TOWN OF VAIL

STREETSCAPE MASTER PLAN ADDENDUM

November 4, 2003

Prepared by:
Town of Vail, Otak Inc., Wenk Associates

Figure 5: West Meadow Drive, Cross section

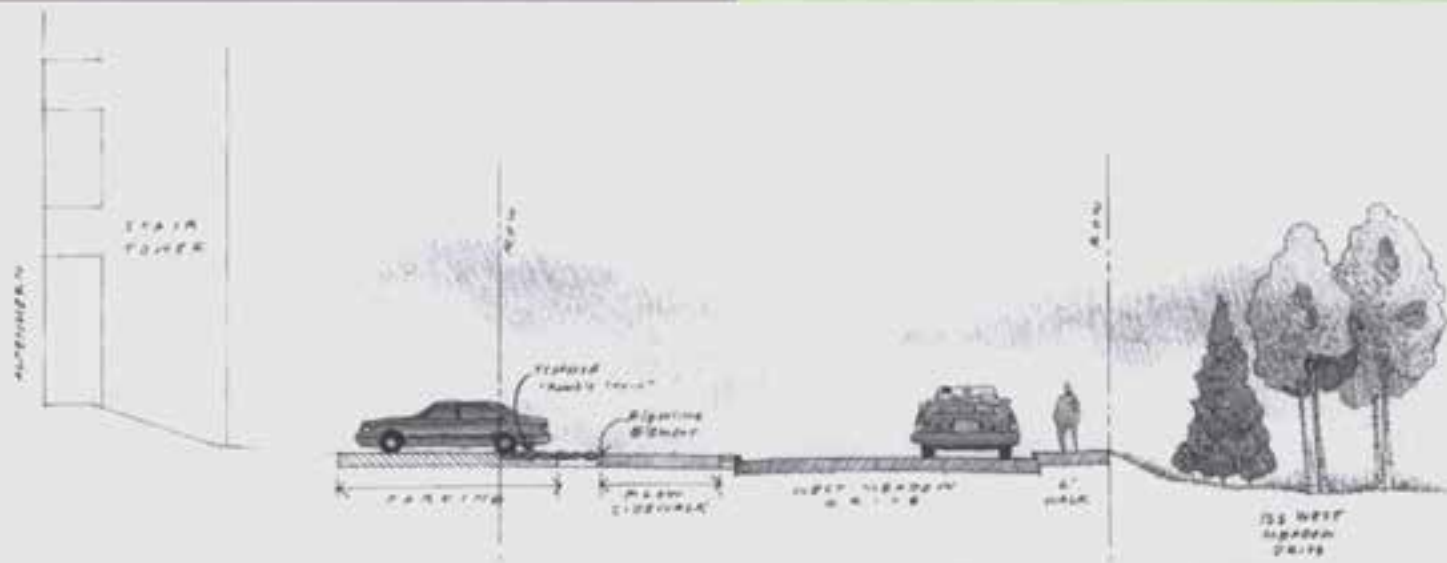
Master Plan Recommendation	Change under Final Design
2. Provide a five foot walkway on the opposite side of the street.	Provide a six foot walkway in accordance with the Town standards.
3. Maintain a street width of 26 feet curb to curb.	To provide more pedestrian and landscape area, design a street width of 24 feet, curb to curb. (Figure 5)

Figure 9: East Meadow Drive Plan View – Vail Road to Willow Bridge Road

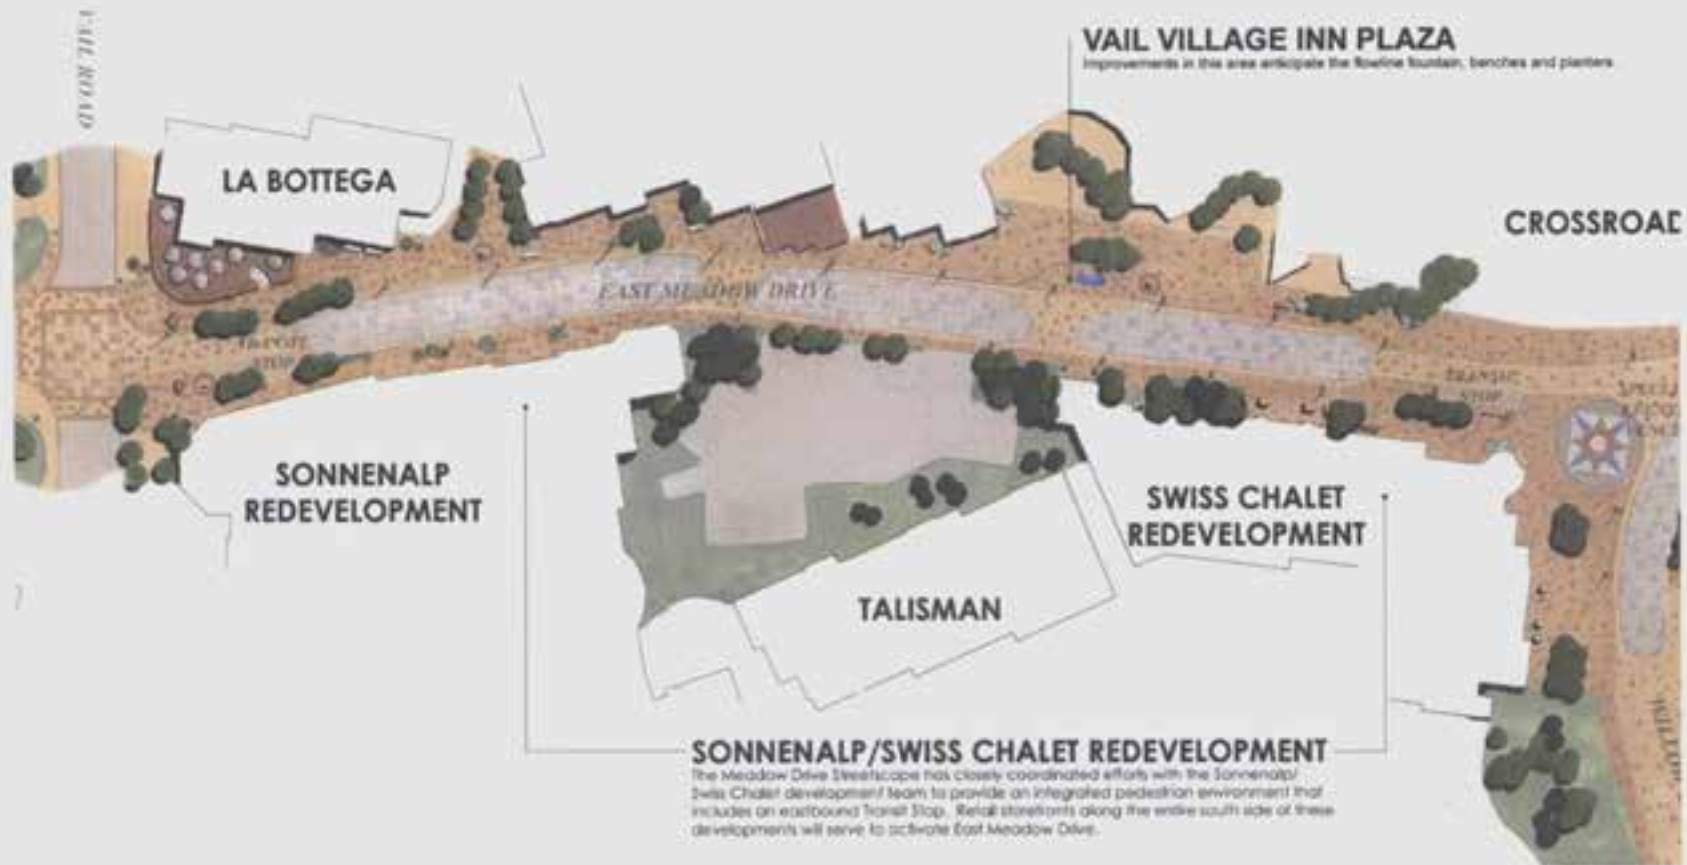
Master Plan Recommendation	Change under Final Design
1. Provide a single 14-foot travel lane for buses.	Two-way bus movement is required on East Meadow Drive using 12 foot lanes. As suggested in the Master Plan, the lanes are placed as far south as possible within the right-of-way. The roadway width is reduced to one 12 foot lane at each end as a traffic control measure.

2. Maintain control gates as a streetscape element.	Replace control gate arms with lane restriction “neck-downs” with special paving on both ends of the street. This treatment de-emphasizes East Meadow Drive as a public road for vehicles. Pedestrian-style paving is drawn into the “neck-down” zone to emphasize the corridor as a pedestrian area.

Figure 10: East Meadow Drive – Sonnenalp Redevelopment Area

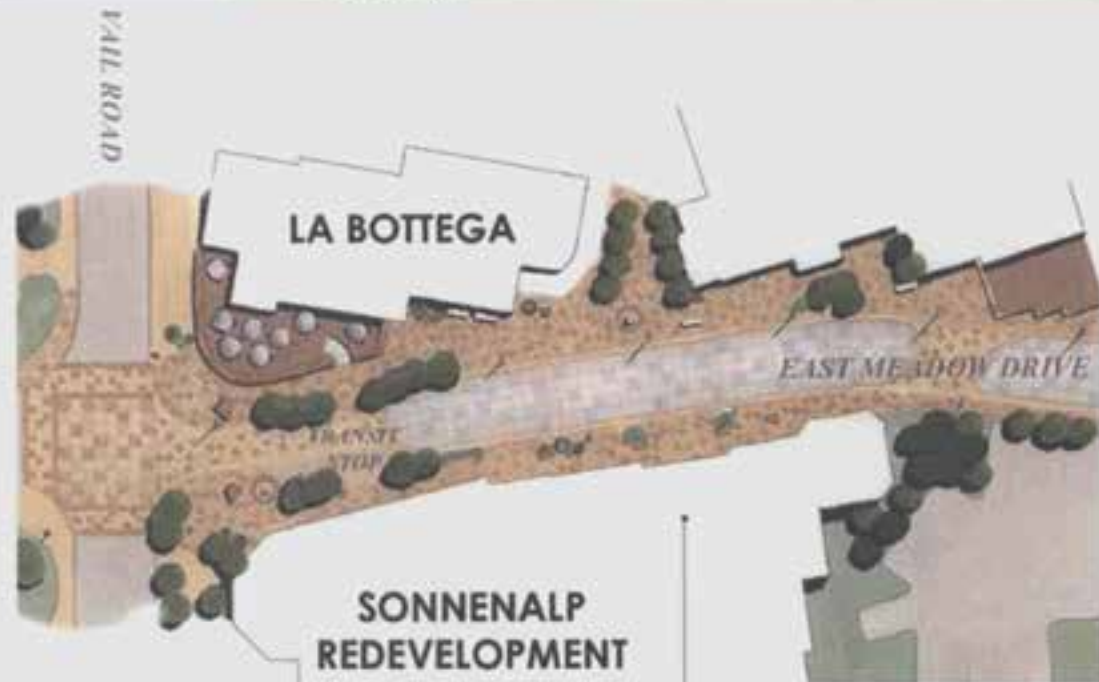
Final design is consistent with the Master Plan, except for the far end of the street. The preliminary Sonnenalp redevelopment plans bring the new building to the edge of the right-of-way, with store fronts along the south side of the street. Final design includes an eight foot pedestrian walkway along the south side of the street. The west end of the walkway is located within the right-of-way and on Sonnenalp property. As the walkway continues to the east, it transitions fully onto Sonnenalp property.

Figure 18: Crossroads Area

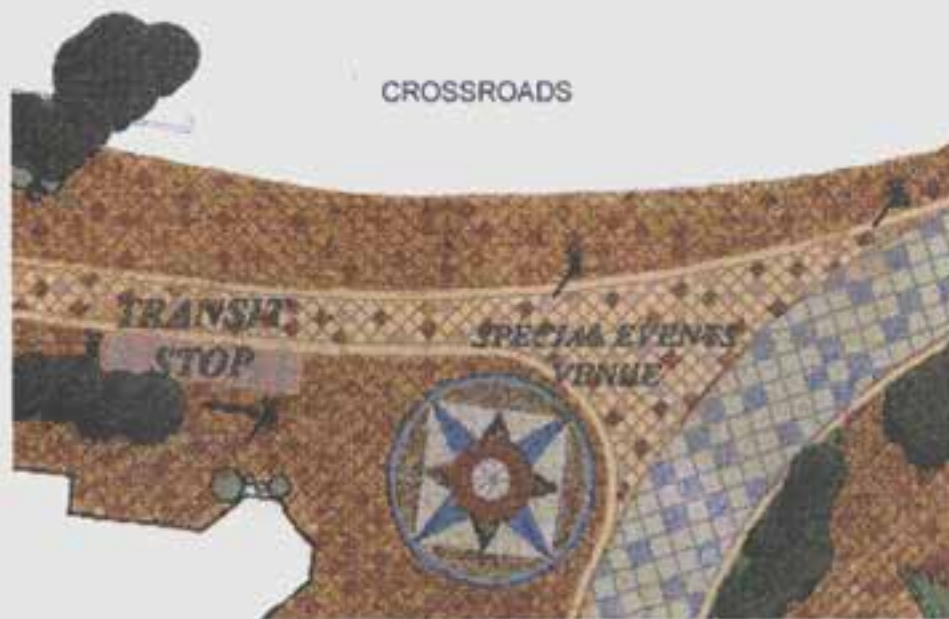
3. Replace the triangular planter located in the center of the East Meadow Drive/ Willow Bridge intersection with a larger circular planter. Use a special treatment to pave the intersection so it acts as a focal point.	After considerable traffic movement analysis, it was determined that increasing the dimensions of the existing planter will make it difficult to provide for large truck or emergency vehicle turn-around. The planter is removed in its entirety and replaced with a special paving treatment to create the focal area recommended in the Master Plan. The area is labeled to serve as a venue space for special events, during which buses and other vehicular traffic would be rerouted. Coordination and interface with the Crossroads redevelopment will be critical to setting the stage for this area to serve as a special event venue. (Figure 18)

4. Reduce the width of Village Center Road to 28 feet, curb to curb, with five to six-foot concrete sidewalks on each side.	Reduce the width of Village Center Road to 28 feet, with the addition of a central landscape median to further discourage unnecessary traffic. The landscape median also responds to the Master Plan recommendation to add landscaping along Village Center Road near the South Frontage Road intersection. (Figure 19)

Figure 26: West Gore Creek Drive

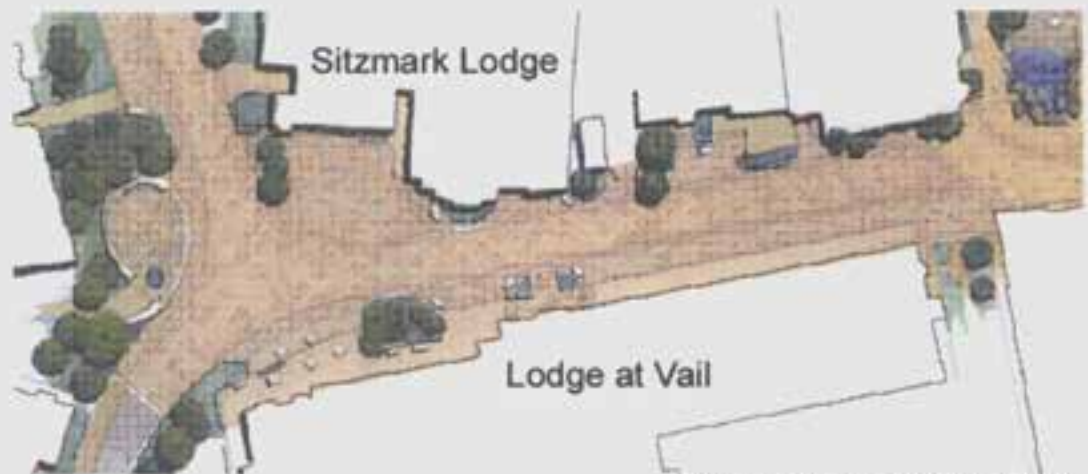
Master Plan Recommendation	Change under Final Design
<p>4. Along Gore Creek Drive in front of the Lodge at Vail, the Plan suggests removing as much of the existing rock wall that separates the sidewalk from the street as possible, replacing it with steps.</p>	<p>The final design proposes to remove the existing steps, stone walls, and handrails along the Lodge at Vail Promenade shops. The adjacent section of Gore Creek Drive will be reconstruction and graded to eliminate the need for steps and retaining walls.</p>
<p>5. Planters have been suggested at the present Checkpoint Charlie location. The landscaping should be designed to allow for possible performances by street musicians and other artists.</p>	<p>Initially, Checkpoint Charlie will remain as it is. Discussions ensued to relocate it to the intersection of Vail Road and Willow Bridge Road; however, the relocation will largely depend on the design of the Front Door project. If relocated, the existing planter can be removed and replaced with an architectural landmark creating a visual connection with Bridge Street and East Meadow Drive and provide additional performance and display opportunities</p>
